Engineering Change Notification

NHD-3.5-640480EF-MSXP-CTP
NHD-3.5-HDMI-HR-RSXP-CTU

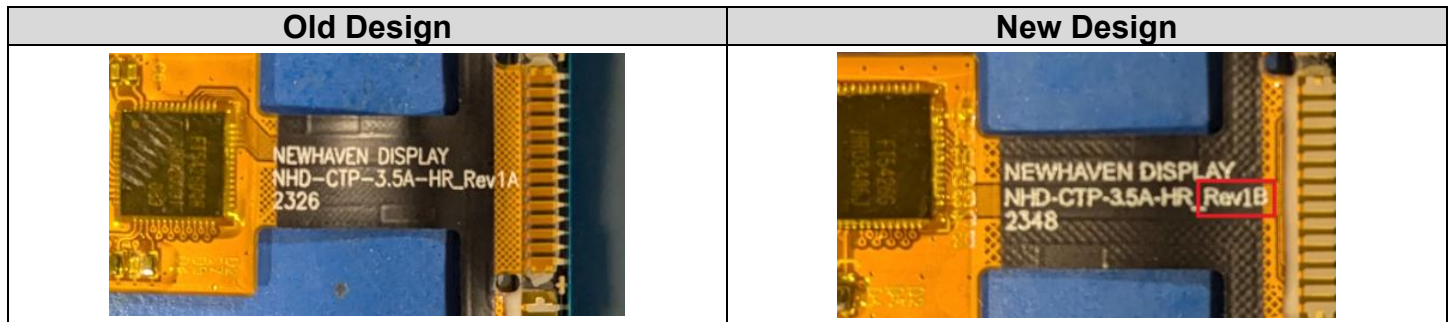
The new touch panel will be labeled with a different revision control number on the FPC. See example below.
